**UNIVERSITY OF NEW ENGLAND**

ALUMNI HALL RENOVATION

**EGRESS**

LS1

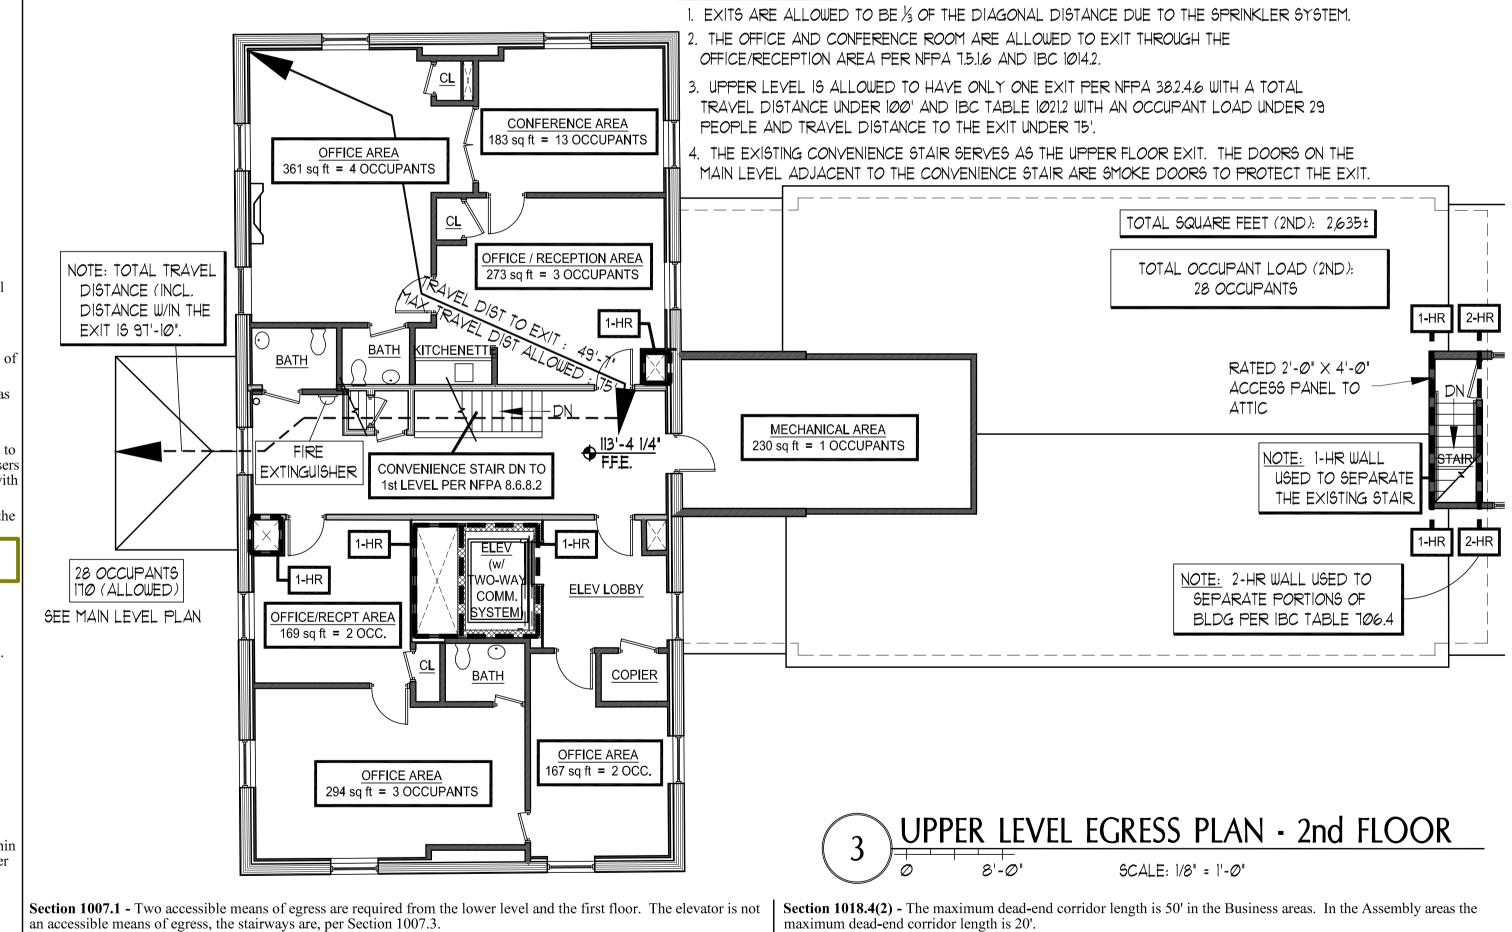
#### Please confirm there are no contradictions with the adopted code. Code Review - IBC 2012 IBC 2009

Please provide a code review per the UPC 2009 for Date plumbing fixture requirements
